DOCKET ITEM #12
Development Site Plan #2016-0025
Street Name Case #2017-0001
Karig Estates – Single-Family Dwellings
3832-3834 Seminary Road

DSP#2016-0025
SNC#2017-0001
Karig Estates
3832-3834 Seminary Road

Graphic B: Front Yard Modification Exhibit

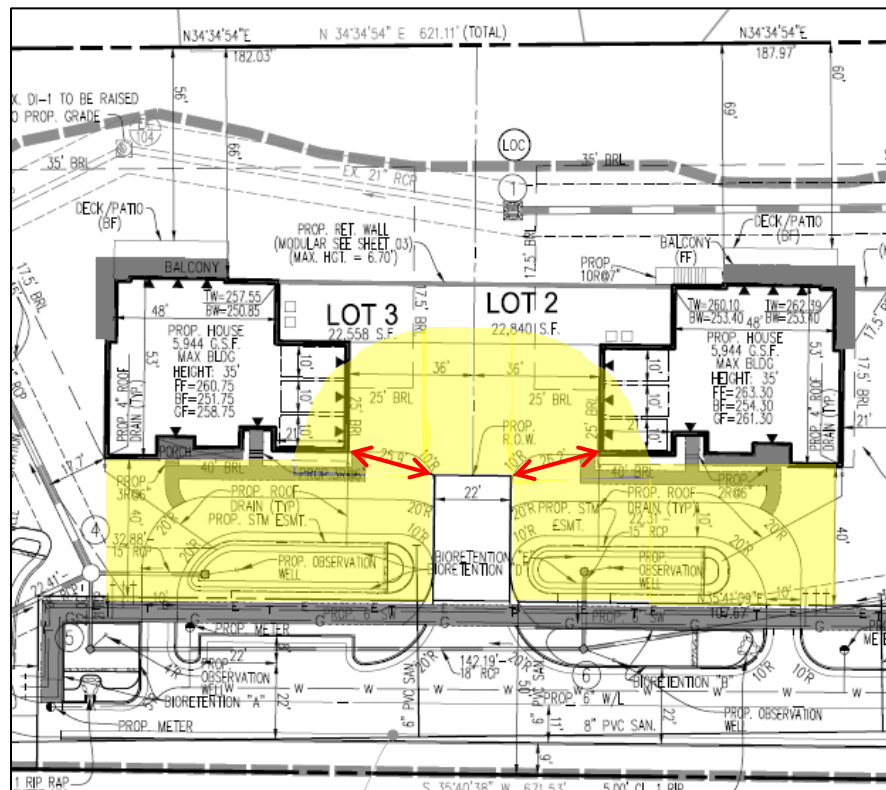
Staff also supports the request for site plan modifications for the front yard setback requirements on Lots 2 and 3. It finds that the proposal meets the three criteria for modifications listed in Section 11-416 as described below.

The requested modifications of the front yard requirement would occur in only two instances: the distance between the corner of the dwelling on Lot 2 and the closest corner of the public right-of-way in the vehicle turn-around area, and a similar measurement between the dwelling on Lot 3 and the closest point of the turn-around. The modification would reduce the setback from 40 feet to approximately 26 feet, a reduction of about 14 feet, at the closest point. To meet the ordinary 40-foot setback requirement, a larger portion of each dwelling and associated grading changes would need to be shifted into the area known as the swale. Staff believes that the modification is

desirable because it would limit the degree of impact to the swale. Although it is not a regulated feature, limiting the changes to the swale to the extent reasonably necessary would support good urban planning practice and good site development.
